March 20, 2018  
15045

**Third Party Review of the Rezoning Petition in Northern Aroostook County, Fish River Chain of Lakes Concept Plan**

### SLOPE EVALUATION OF FISH RIVER CHAIN OF LAKES DEVELOPMENT AREAS

LOCATION: CD-1	FOR: J.D. IRVING LIMITED	INFORMATION: 2011 LIDAR DERIVED DATA PROVIDED BY J.D. IRVING, LIMITED
----------------	--------------------------	---

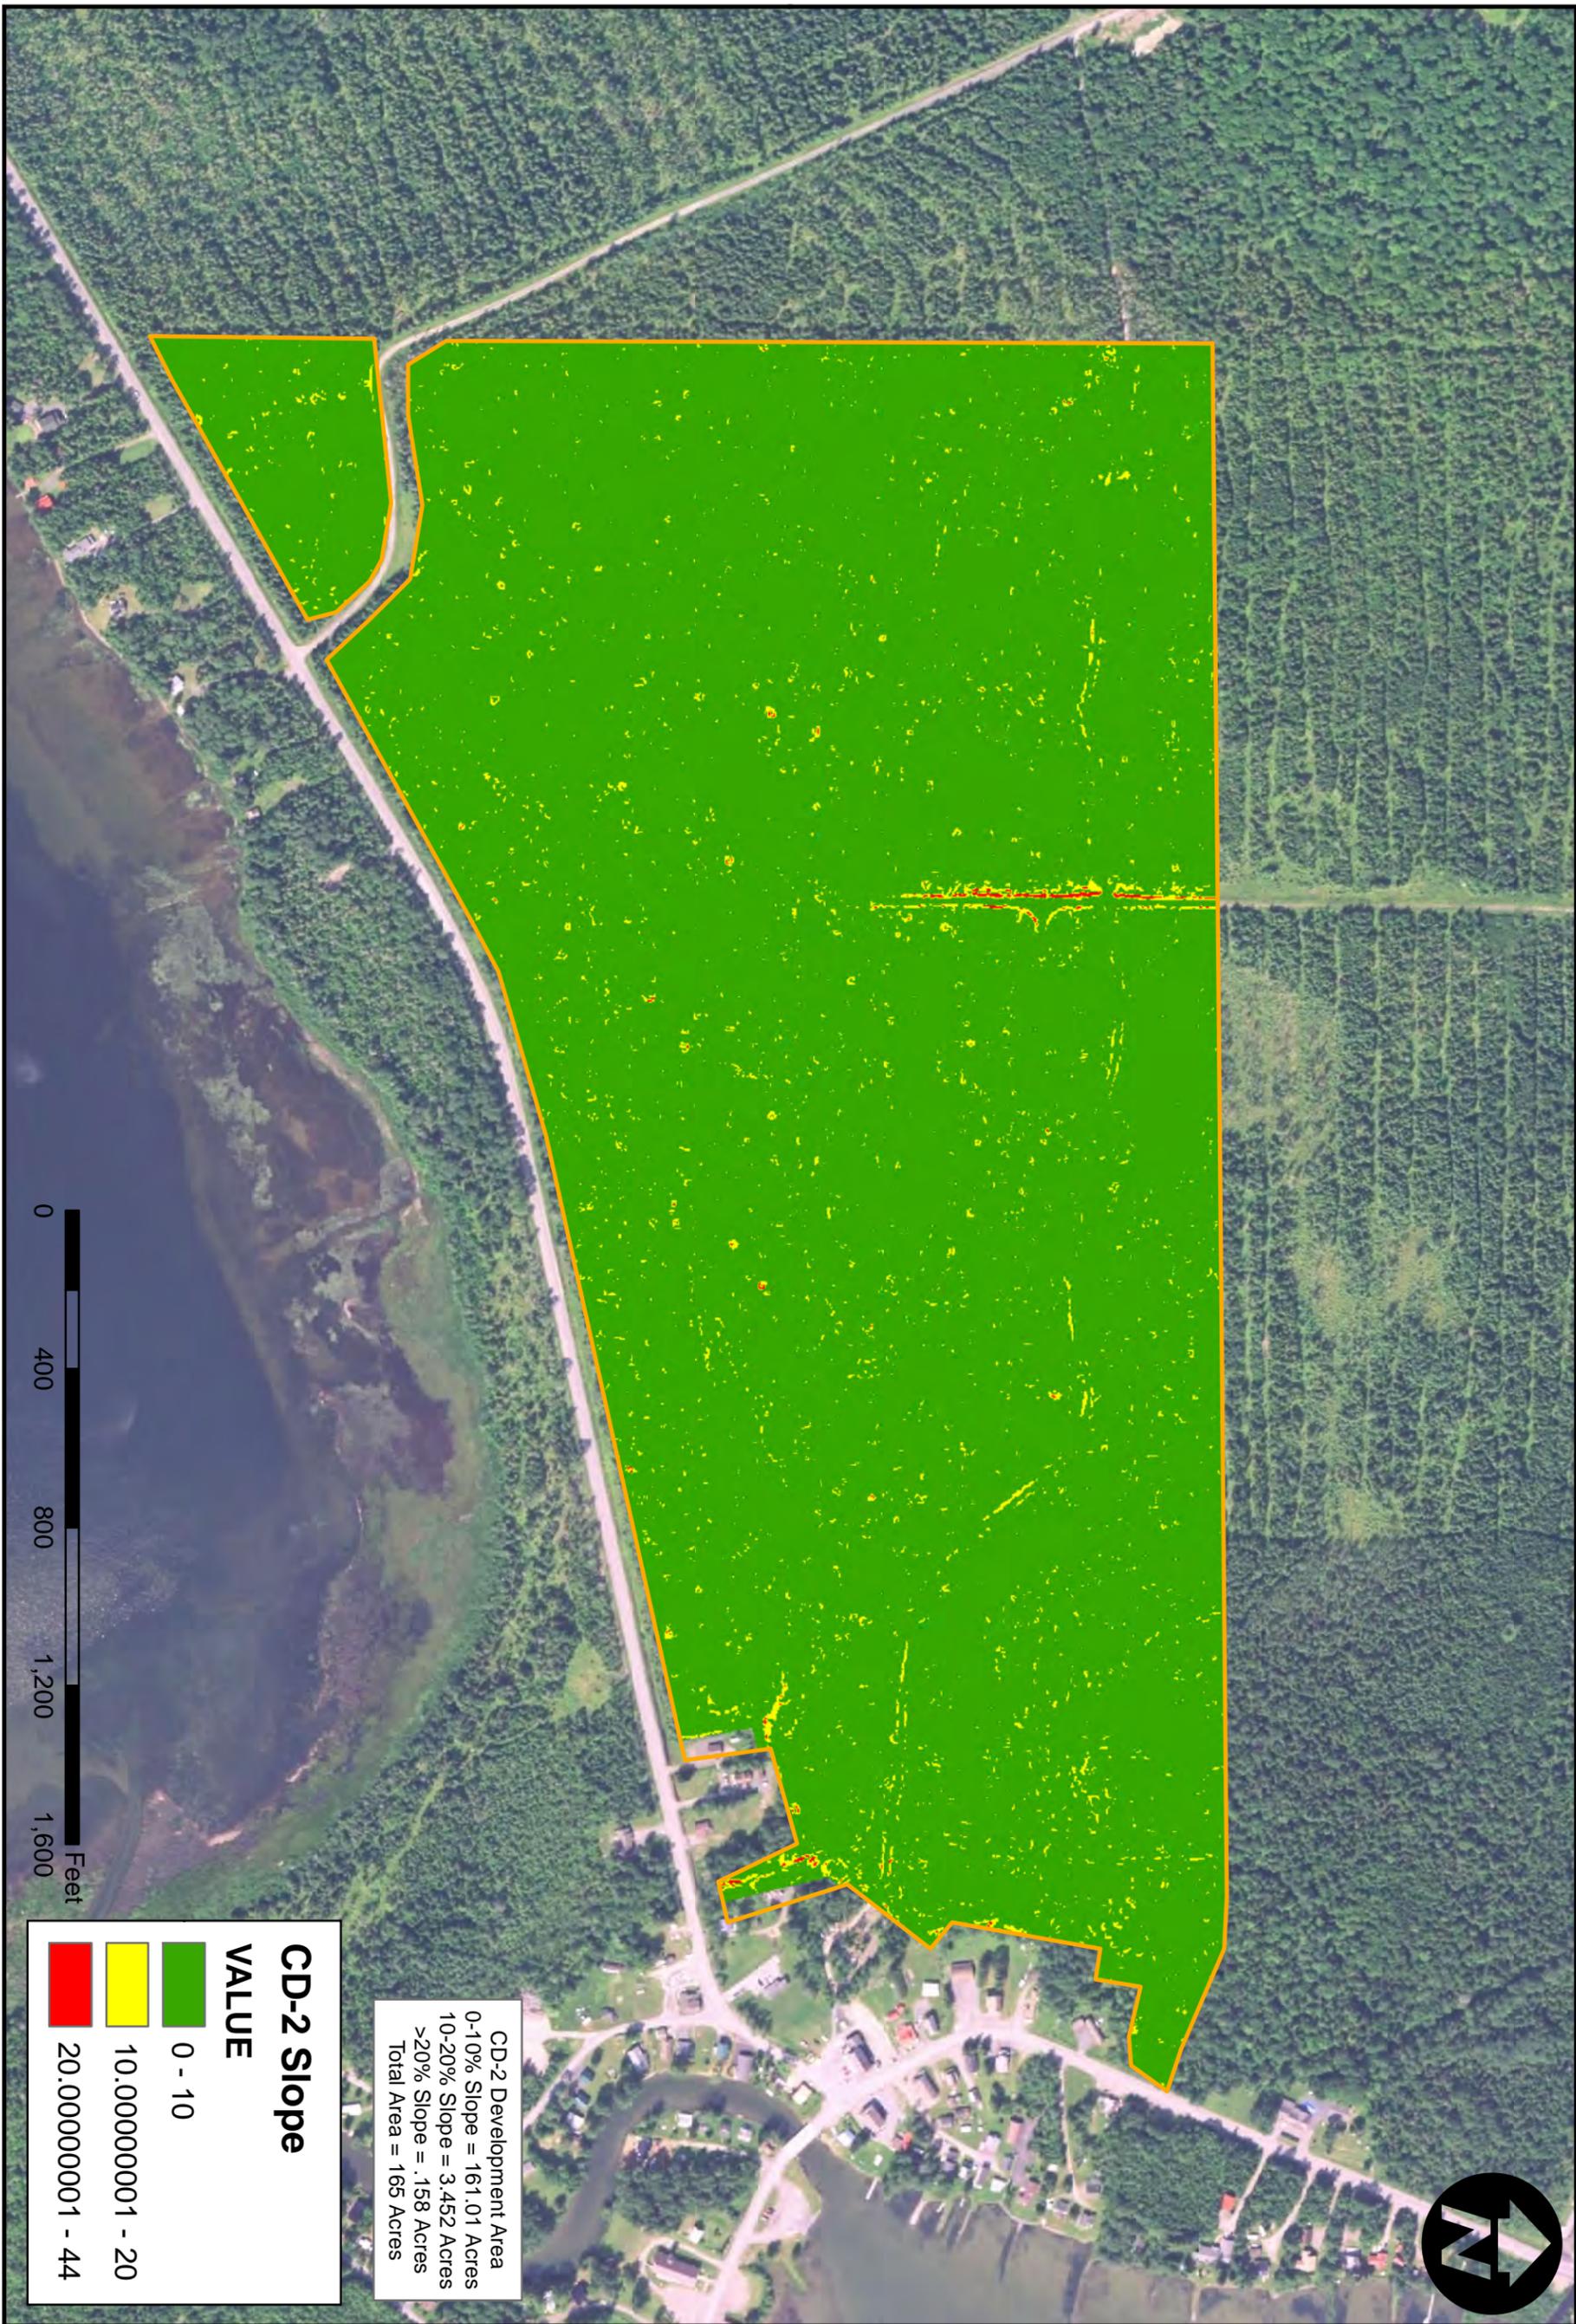
1. Slope Analysis: The slope analysis indicates approximately 1.6 acres of the development area contains slopes greater than 20 percent and are generally considered unsuitable for development. The greater than 20% slopes are few and likely associated with a random slope features. Slopes 0-10% slopes encompass approximately 262 acres. The limited suitability slopes (10 to 20% slopes) encompass approximately 18 acres of the project area. The slope assessment suggests the development area is suitable for the intended purposes noting that the few slopes greater than 20% are not considered suitable for development due to limitations for wastewater disposal systems, erosion and drainage control considerations and slope stability. These areas are very few and will have little or no influence on development.

2. The soils in this development area (NRCS Mapping) mapped as MoA (Monarda-Burnham complex), CdB (Canandaigua silt loam, thin solum), PvB (Plaisted Howland association)

soil series. The MoA and CdB soils are generally a silt-loam, poorly drained with a water table of 0" to 18" and include a hydrologic soil group "D" classification. These soils are indicative of potential wetlands and can be severely limited for subsurface wastewater disposal systems due to the depth to groundwater. Any development on these soils will require substantive engineering considerations for dewatering, subsurface wastewater disposal, higher erosion potential and potential difficulties addressing stormwater management.

The PvB soils are well drained with a water table depth of 26" or more and considered a hydrological group "C". These soils are generally suitable for development.

Since the CdB and MoA to the soil are prominent and located between the probably point of access and developable soils, we recommend field mapping of the wetlands and a site-specific soils survey to verify the soils, their limitation and the overall suitability of the parcel for development including means of access to the developable area. We understand some limited site-specific evaluations were completed but believe additional more specific work is required to assess the suitability of this land for development.

LOCATION: CD-3b/CD-3c/CD-4	FOR: J.D. IRVING LIMITED	INFORMATION: 2011 LIDAR DERIVED DATA PROVIDED BY J.D. IRVING, LIMITED
-------------------------------	-----------------------------	--

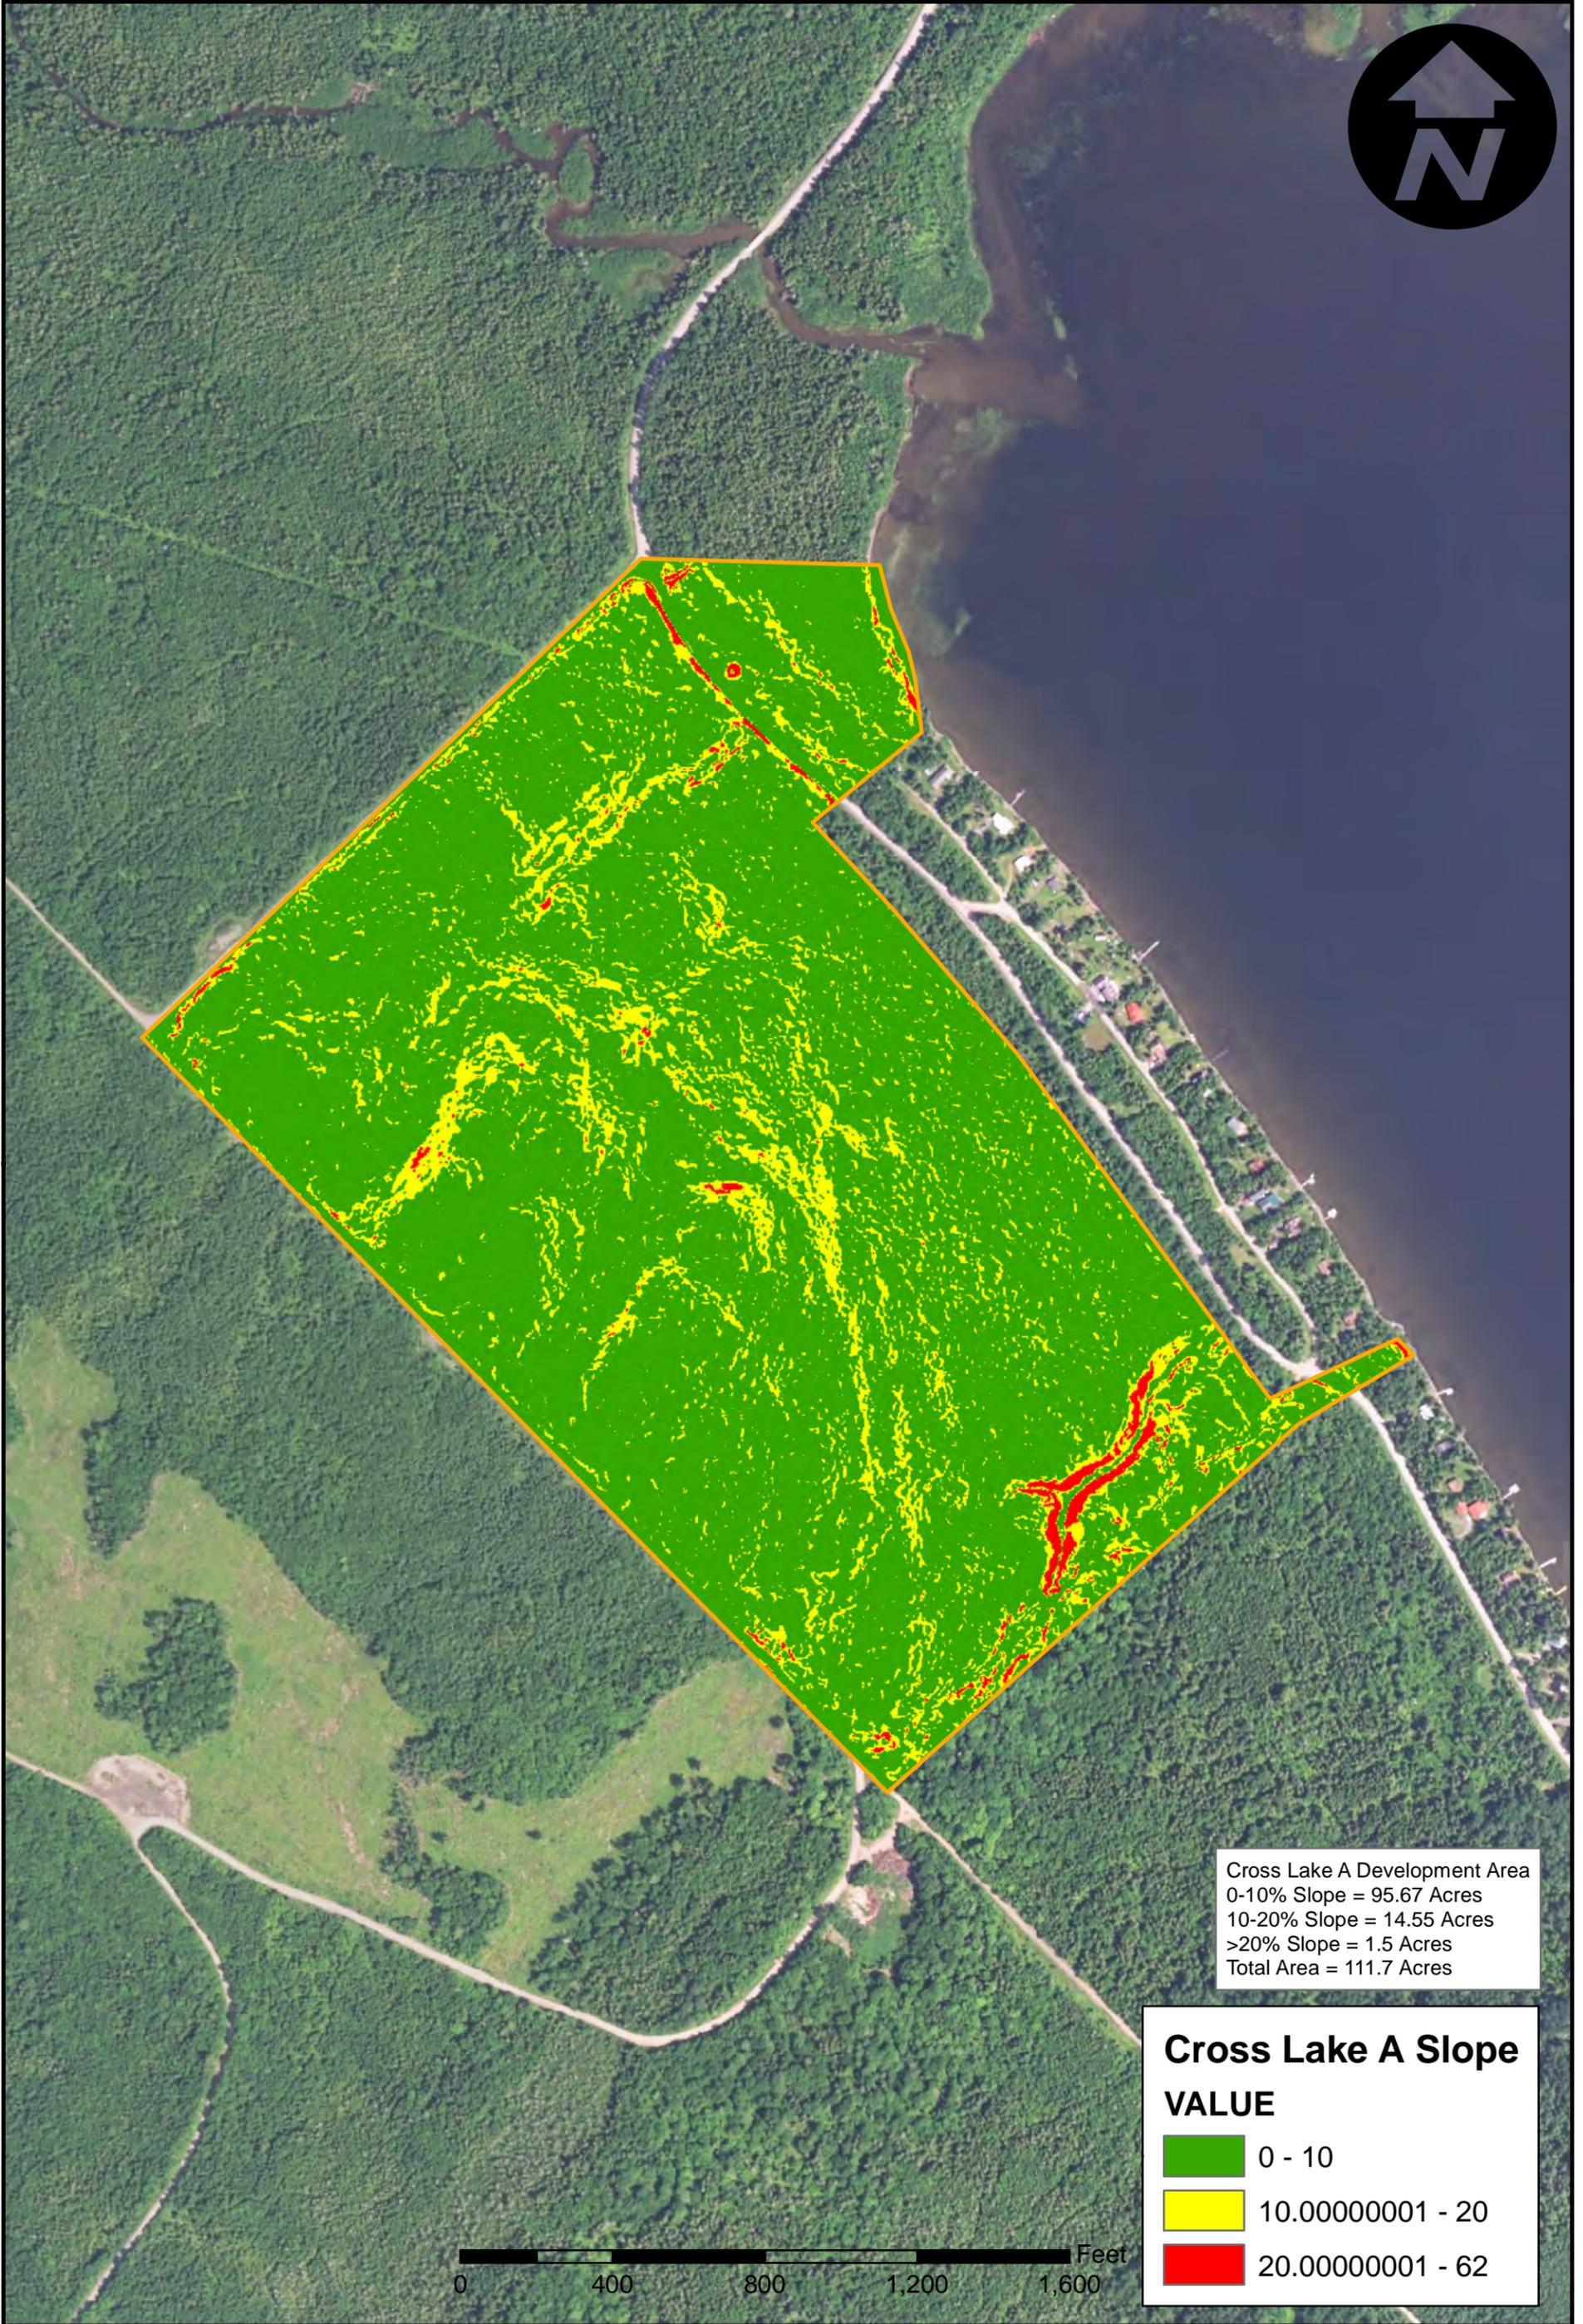
1. Slope Analysis: The slope analysis indicates the majority of the parcels contain slopes in the 0 to 10 percent range with only a very small component with slopes greater than 20%. Therefore, all four development areas are considered to have suitable slopes for development.

2. The soils in this development area (NRCS Mapping) are mapped as RaA (Red Hook and Atherton silt loams), and an area of MaB (Machias gravelly loam) soil series. The RaA soils are generally poorly drained and include a water table of 6" to 18" with hydrologic group B/D classification. These soils are indicative of potential wetlands and can be moderately limited for subsurface wastewater disposal systems due to the depth to groundwater. Any development on these soils will require substantive engineering considerations for dewatering, subsurface wastewater disposal, higher erosion potential and potential difficulties addressing stormwater management.

The MaB soils are moderately well drained with a water table depth of 18" or more and considered a hydrological group "B". These soils are generally suitable for development.

Since the RaA soil are prominent we recommend field mapping of the wetlands and a site-specific soils survey to verify the soils, their limitations and the overall suitability of the parcels for development. Given the peculiar shape of CD-3a and the narrow linear configuration of CD-3b these lots maybe overly restrictive for development. We understand some limited site-specific evaluations were completed but believe additional more specific work is required to assess the suitability of this land for development.

LOCATION: CROSS LAKE B	FOR: J.D. IRVING LIMITED	INFORMATION: 2011 LIDAR DERIVED DATA PROVIDED BY J.D. IRVING, LIMITED	SCALE: 1" = 500'
			DATE: 03/07/18

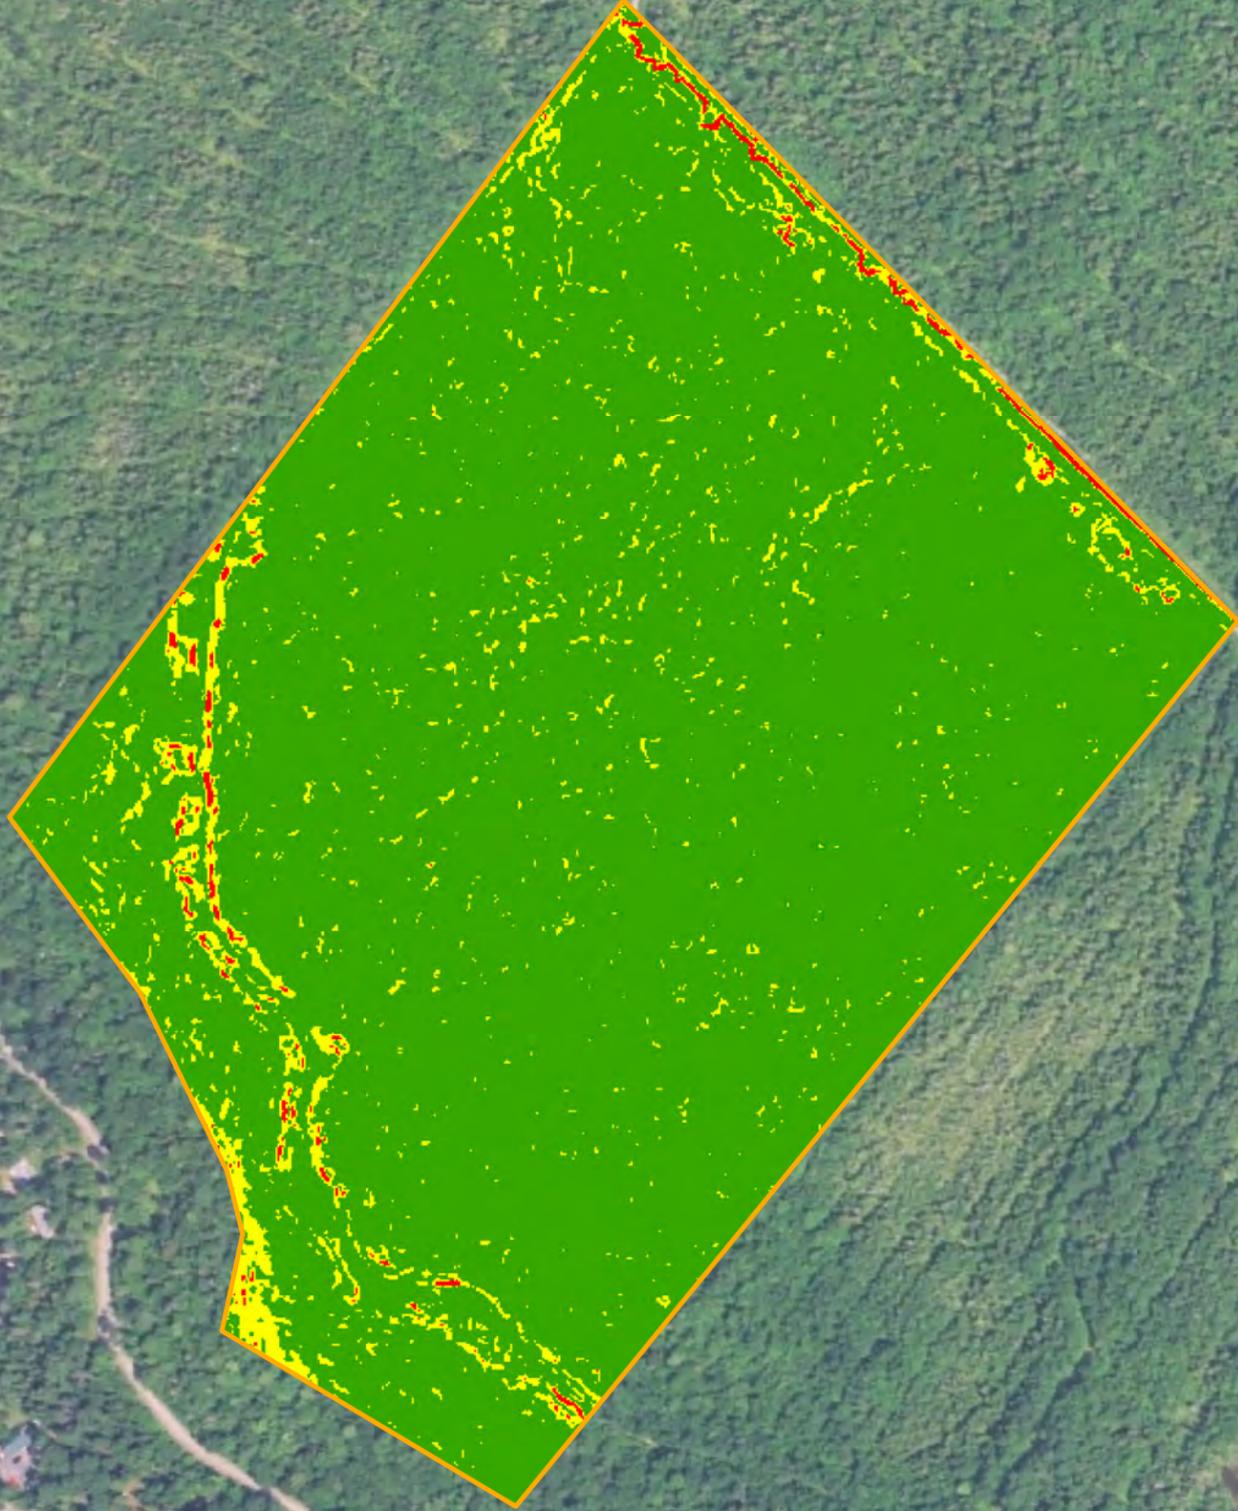
1. **Slope Analysis:** The slope analysis indicates approximately 1.8 acres of the development area contains slopes greater than 20 percent and are considered unsuitable for development. The greater than 20% slopes are few and likely associated with high points or continuous slope features. Slopes 0-10% slopes encompass approximately

88.3 acres. Limited suitability slopes (10 to 20% slopes) encompass approximately 9 acres of the project area. The slope assessment suggests the development area is suitable for the intended purposes noting that the few slopes greater than 20% are not considered suitable for development due to limitations for wastewater disposal systems, erosion and drainage control considerations and slope stability. These areas are very few and will have little or no influence on development.

2. The soils in this development area (NRCS Mapping) are mapped as RaA (Red Hook and Atherton silt loams), SgB (Stetson gravelly loam) and MaB (Machias gravelly loam) soil series. The RaA soils are generally poorly drained and include a water table of 6" to 18" with hydrologic group B/D classification. The MaB soils are moderately well drained and include a water table of 18 to 36 inches and carry a hydrologic group B classification. SgB soils are well drained with a water table greater than 80 inches and carry a hydrologic group A classification. The RaA soils are indicative of potential wetlands and can be moderately limited for subsurface wastewater disposal systems due to the depth to groundwater. Mapping indicates these soils areas are relatively few and should not pose any appreciable concerns. We do note that any development on the RaA soils would require substantive engineering considerations for dewatering, subsurface wastewater disposal, higher erosion potential and potential difficulties addressing stormwater management.

The MaB and SgB soils are moderately well to well drained with a water table depth of 18" or more. These soils are generally suitable for development.

Considering the soil types and associated development limitations including slopes over 20%, our assessment suggests that the project area and number of planned units (30) yields an effective net density of 2.5 acres/unit. This represents a reasonable and appropriate net development density (Please refer to the development matrix analysis appended to this report). This assessment includes deductions for slopes over 20% and allowing for 25% of the 10% to 20% (limited suitability slopes) to be considered not suitable.
